To: T10 Technical Committee
From: Rob Elliott, HP (elliott@hp.com)
Date: 12 July 2008
Subject: 08-283r0 SAS-2 SNW-3 SATA port selector confusion

Overview

Figure 151 — SAS speed negotiation sequence (phy A: SNW-3 only, phy B: SNW-1 only)

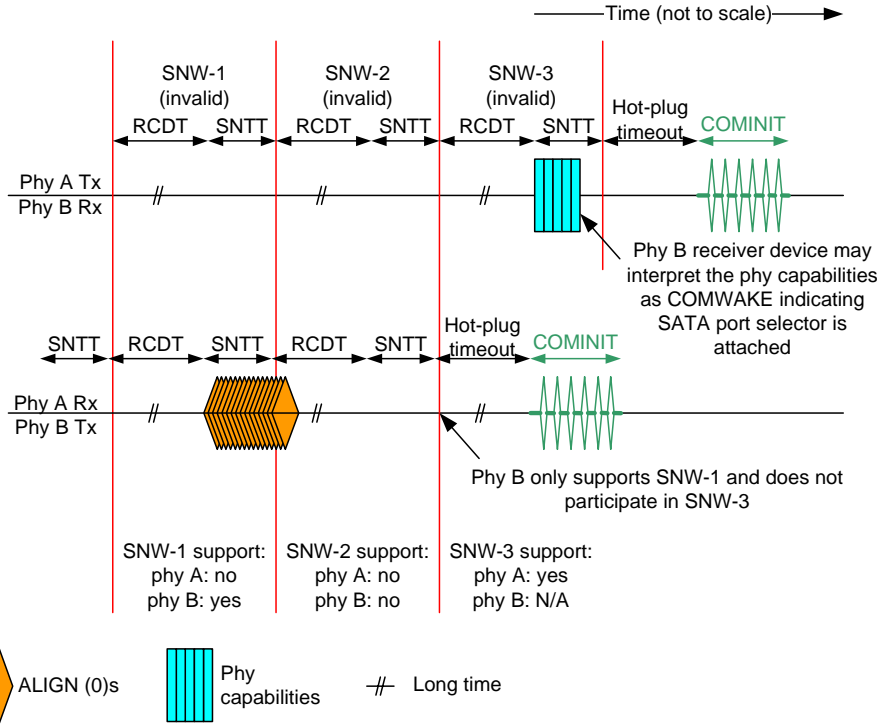
Mark Seidel (Intel) identified a problem with the COMWAKEs used in SNW-3 by SAS-2 phys confusing phys that only participate in SNW-1 into thinking that a SATA SATA port selector is present. This was carried in an editor's note for several revisions prior to sas2r14, and submitted as a letter ballot comment on sas2r14. sas2r14c includes a description of the problem, including a figure, but does not include any solutions.

Since a phy capabilities bit set to one is defined as COMWAKE (see table 97 in 6.7.4.2.3.3), phy B interprets the first phy capabilities bit set to one from phy A as being a COMWAKE in response to its COMINIT during the OOB sequence. This falsely identifies a SATA port selector and causes phy B to incorrectly set its ATTACHED SATA PORT SELECTOR bit to one in the SMP DISCOVER response (see 10.4.3.10).

When phy B transmits COMINIT during SNW-1 of the next OOB sequence, phy A detects that a SAS phy is attached, not a SATA phy, and sets the ATTACHED SATA PORT SELECTOR bit to zero in the SMP DISCOVER response. However, the phys may keep repeating this process after each hot-plug timeout.

An expander device originates Broadcast (Change) whenever the ATTACHED SATA PORT SELECTOR bit changes from zero to one (see 7.12), so this results in Broadcast (Changes) at hot-plug timeout intervals.

Figure 152 — SAS speed negotiation sequence SNW flowchart [changed]

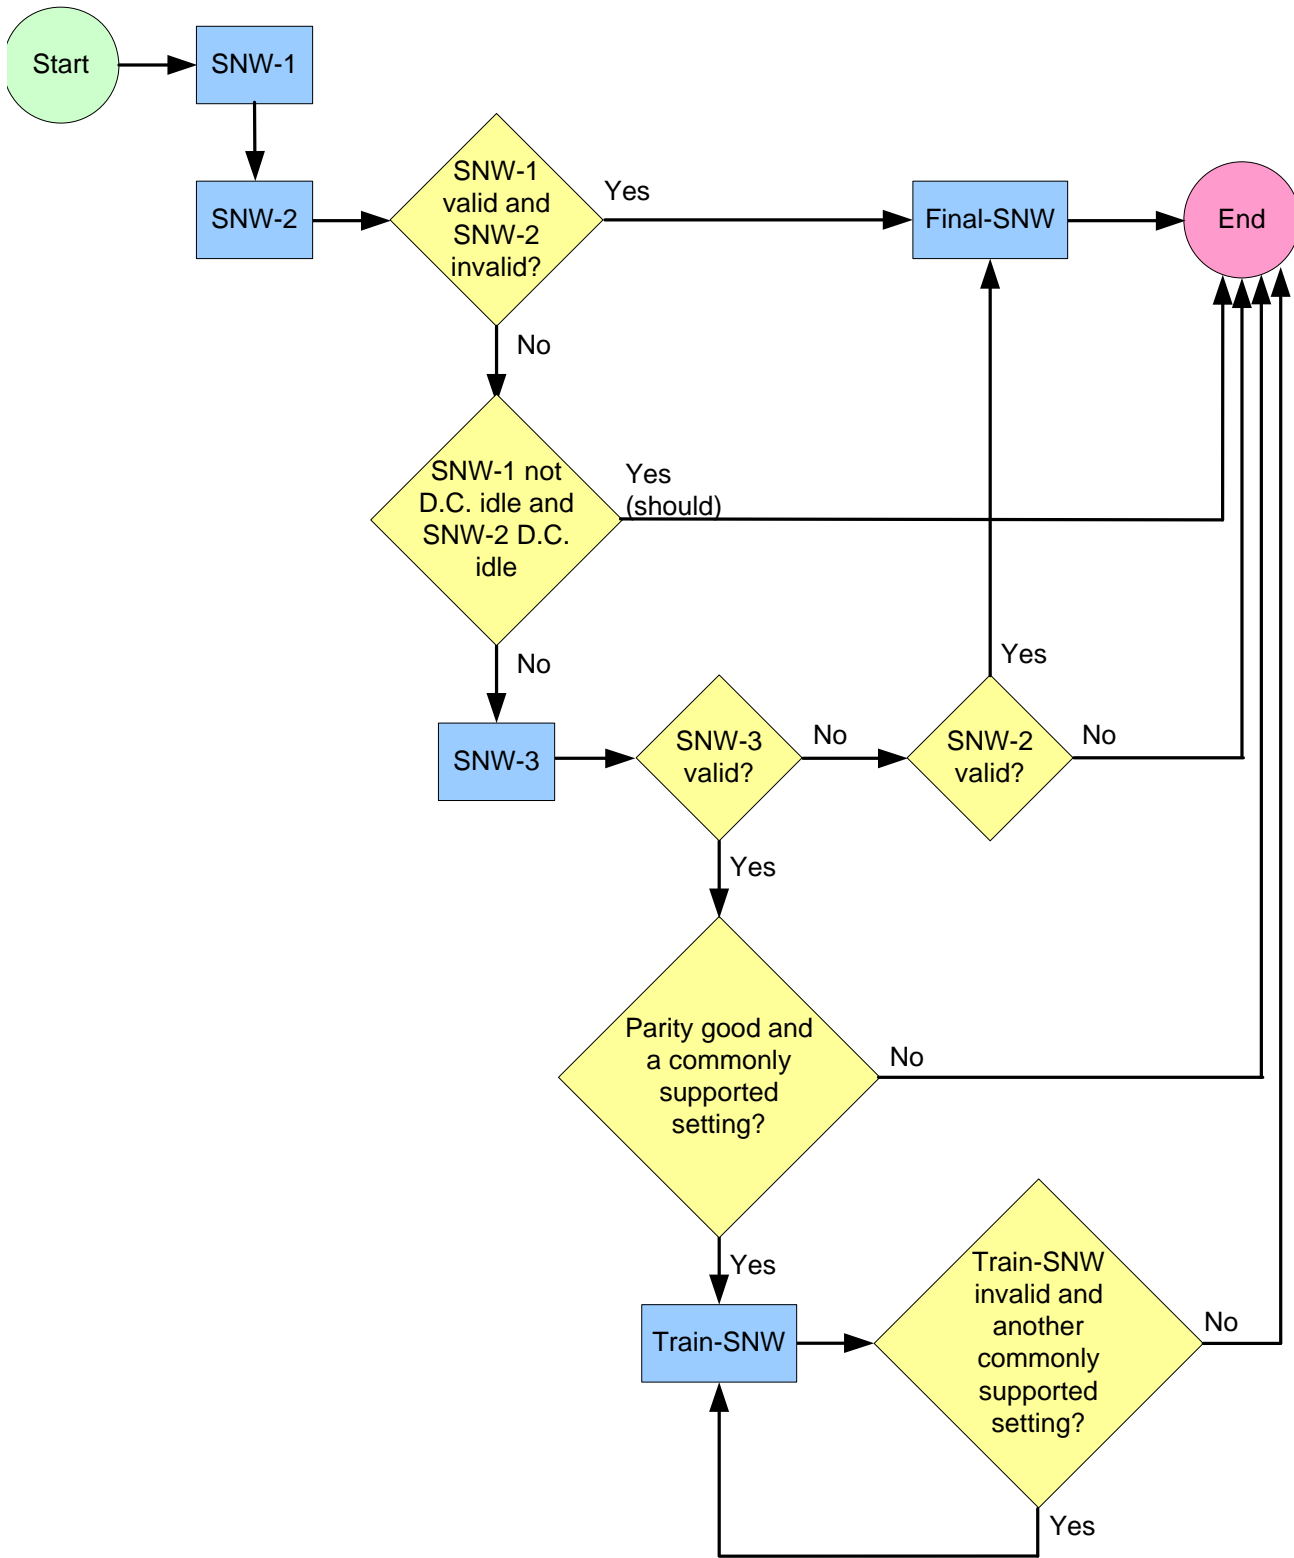
Editor's Note 1: Note that if SNW-1 and SNW-2 are both invalid, a SAS-2 phy still sits through SNW-3. It only skips SNW-3 if SNW-1 is valid and SNW-2 is invalid.

To avoid causing an attached phy compliant with a previous version of this standard for misdetecting a SATA port selector, a phy should detect whether the physical link is D.C. idle during SNW-1 and SNW-2, even if it does not support that SNW. If the phy detects:

- a) SNW-1 is not D.C. idle; and
- b) SNW-2 is D.C. idle,

then it should end the speed negotiation sequence without progressing to SNW-3.

Figure 151 — SAS speed negotiation sequence (phy A: SNW-3 only with D.C. idle detection, phy B: SNW-1 only)

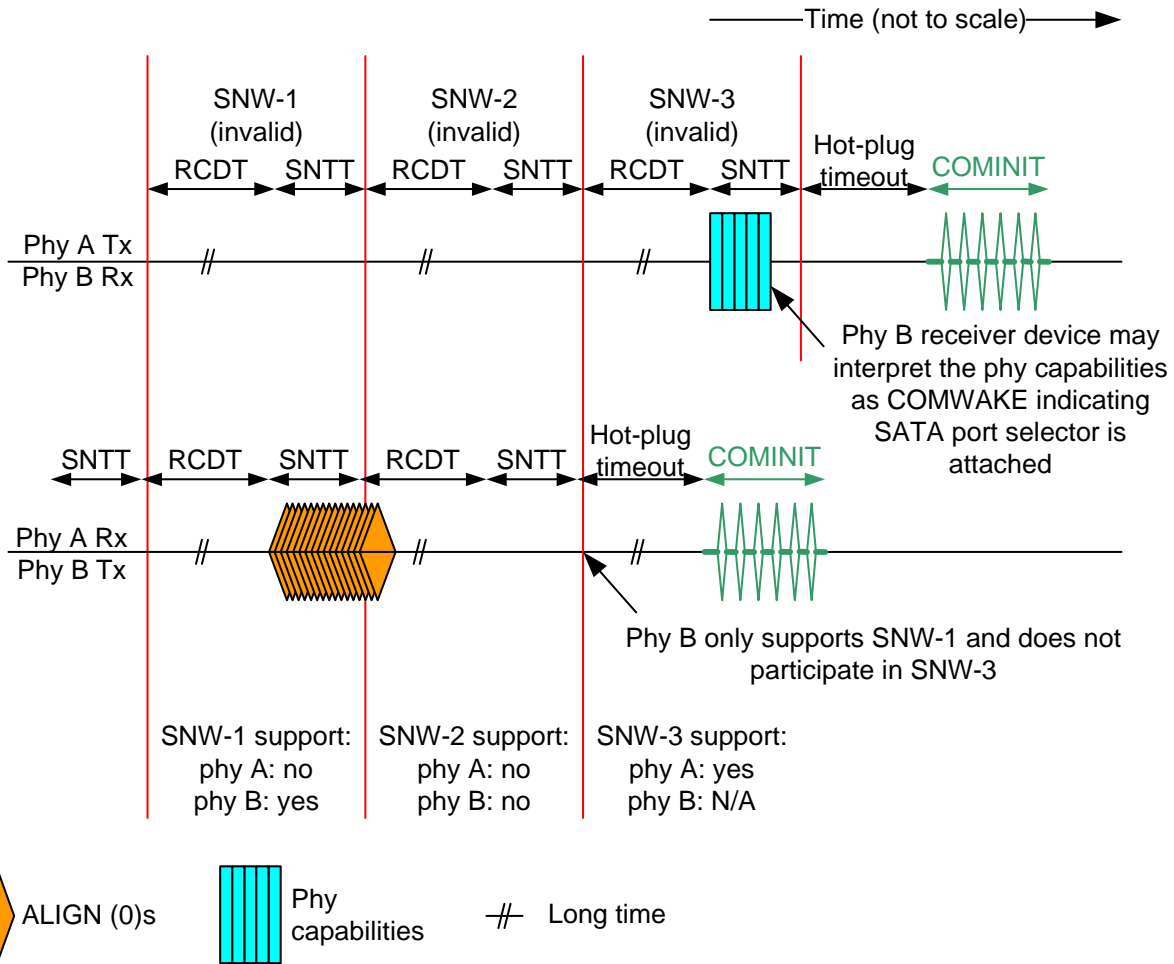
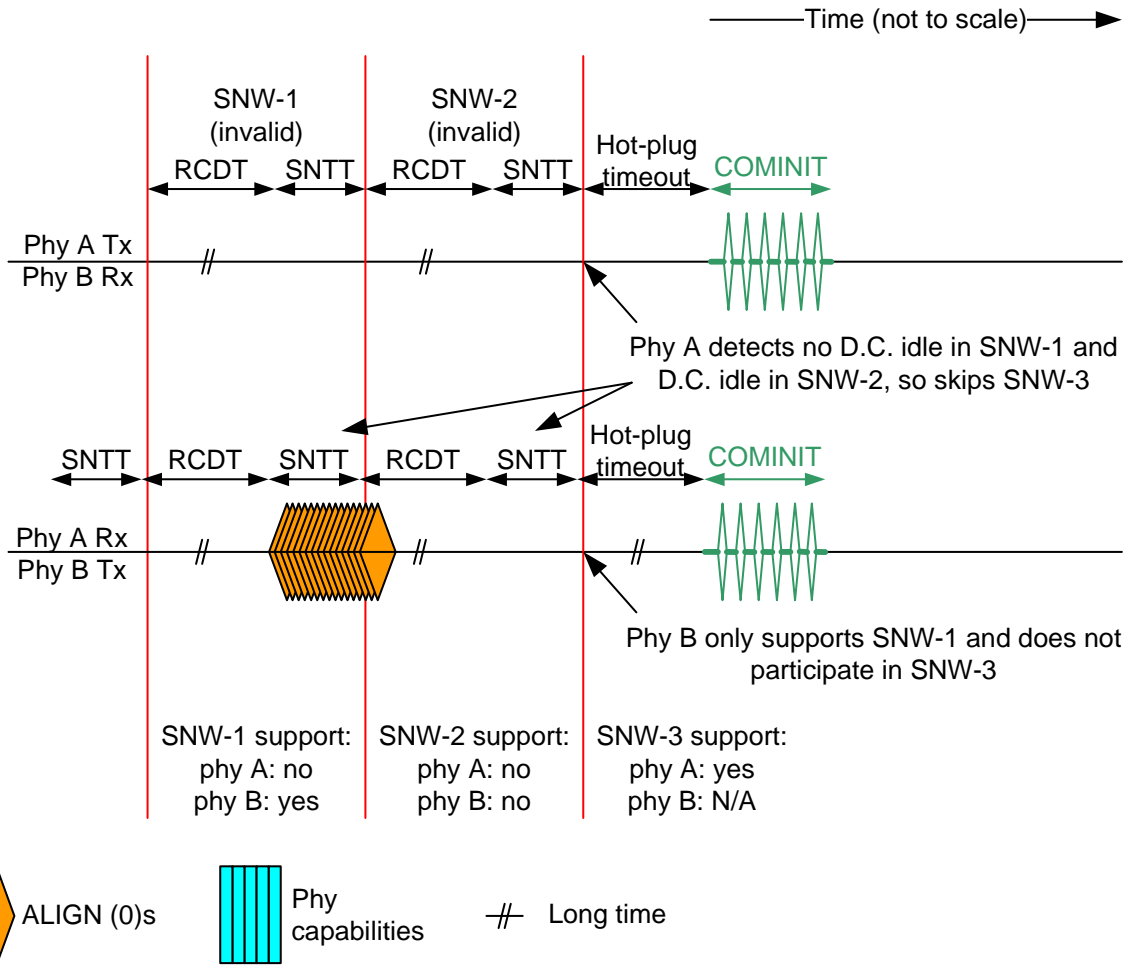
If phy A does not follow the recommendation to detect D.C. idle described in 6.7.4.2.4, then phy Phy A proceeds to SNW-3 while phy B returns to the OOB sequence.

[If phy A does follow the recommendation to detect D.C. idle described in 6.7.4.2.4, then phy A and phy B both return to the OOB sequence.](#)
